DUNSTABLE MOTOCROSS TRACK

REVIEW OF L F ACOUSTICS

NOISE ASSESSMENT

Re VARIATIONS to PLANNING CONDITIONS

Figure 2: Location of Trackside Monitoring Positions

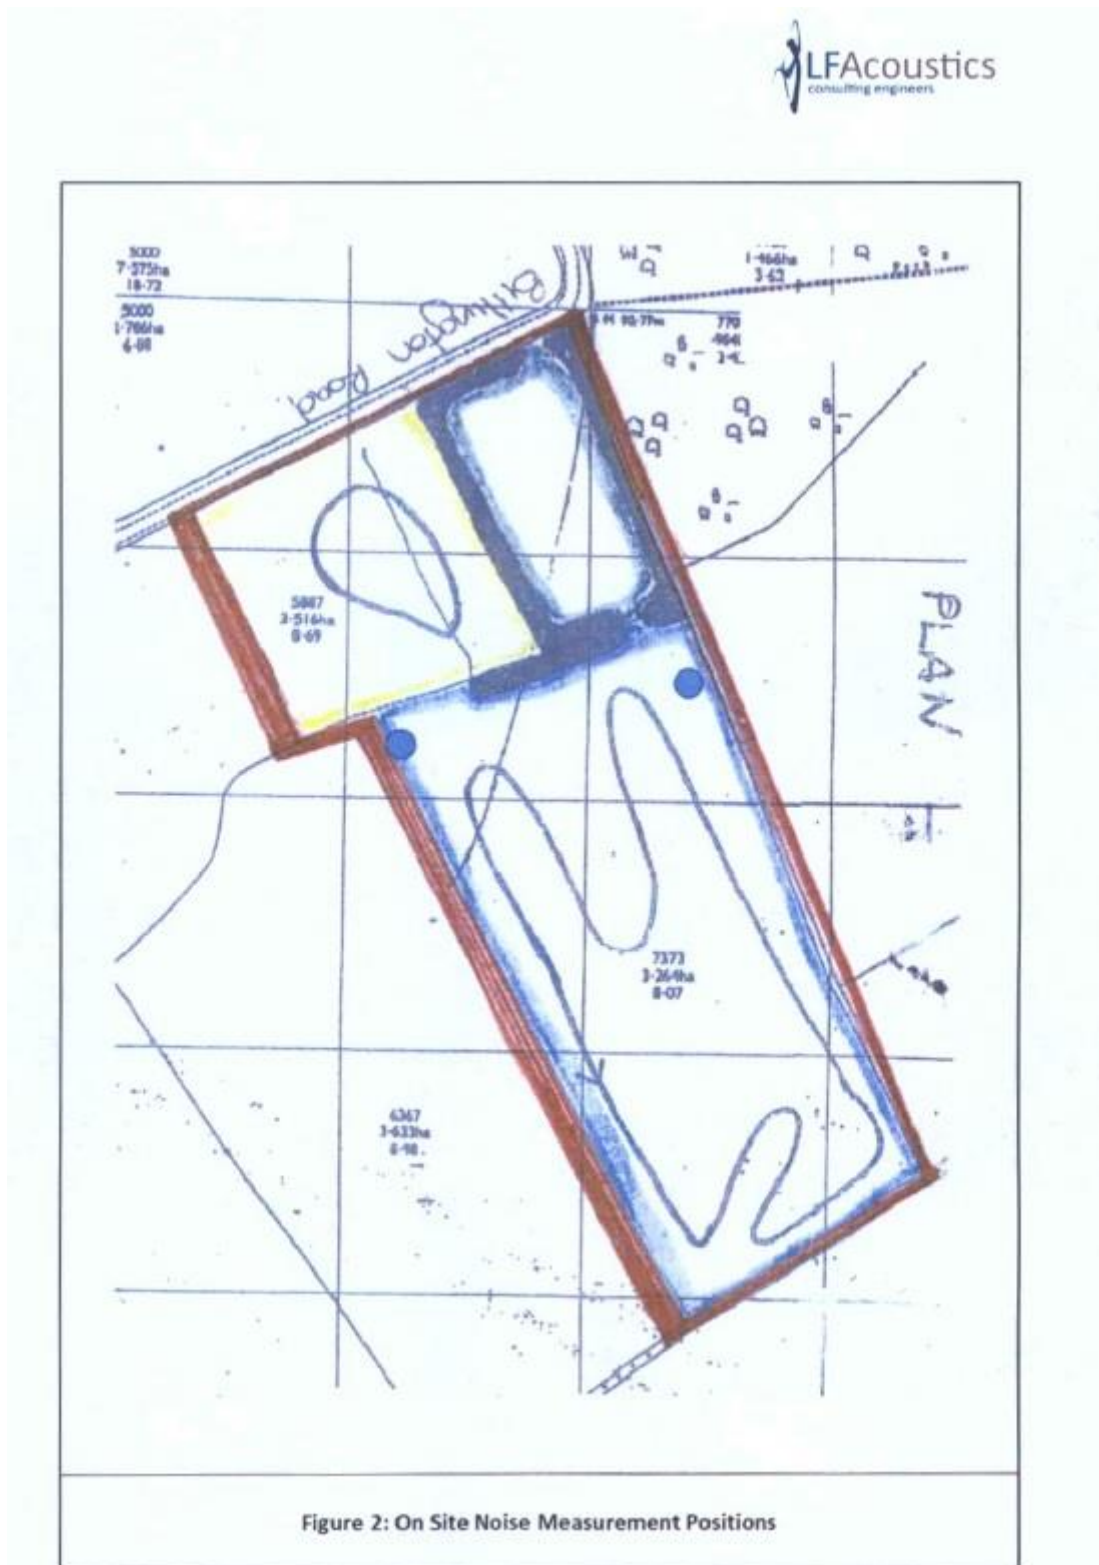
- 6.4 The trackside measurements were made at positions 10 metres from the track and based on distance reduction, for any given noise source, at around 32 metres distance the noise level would be 10 dB lower than at 10 metres. The consequence of distance

- noise reduction is that the noise from bikes more than around 32 metres from the measurement positions would contribute nothing to the measured period $L_{Aeq, t}$ value.

- 6.5 With bikes spread around the track only the noise from bikes within the 32 metre distance will be contributing to the measured noise level and therefore it is not unexpected that there is little variation in the trackside measurements for 7 bikes and 15 bikes. The fact is that no matter how many bikes were on the track, given that the bikes are spread around the track and not racing as a group, a similar number would be within the 32 metre distance whether there was a total of 7 or 15 running on the track.

- 6.7 It is further understood that there was some discussion at this meeting with respect of a noise control criterion for the track operations and that Alan Stone suggested 83 dB $L_{Aeq, 5 \text{ minute}}$. The measurements to be made on top of a bund; this is assumed to be measurement position 2.

- 6.12 As discussed above a trackside noise monitoring position would only control noise over a very small part of the track and is not appropriate should proper control of the noise from the track be exercised. The position of the noise monitor should be inside the track as far as possible equidistant from all parts of the track with measurement data being recorded, archived and available for inspection by the Council should complaint be made.

- 6.11 If anything, consideration should be given to setting a noise control limit lower than the 79 dB $L_{Aeq, 5 \text{ min}}$ measured with 7 bikes rather than any increase in noise level.

- 6.13 The appropriate noise control limit for such a system would be based on achieving a noise control level at the houses of no more than 46 dB $L_{Aeq, 5 \text{ min}}$. This level being 5 dB below the average ambient noise level in the area.
